Access Compliance Report

Public Rights-of-Way

(Curb Ramps)

Intersection ID: 15036	Main Street: MAGNOLIA_AV	Cross Street: MCDONALD_AV	Location: SE
ADA ID: 46E828410325	Ramp Type: Directional1	Initial Pass/Fail: Fail	Overall Compliance: No
		Severity Score: 13.75

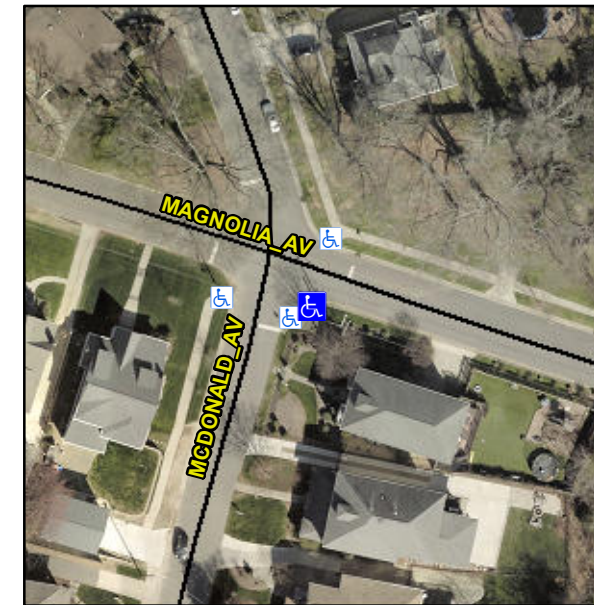
NO LNDG

R304.2.2, R304.5.3

Remove & Replace Entire Ramp.
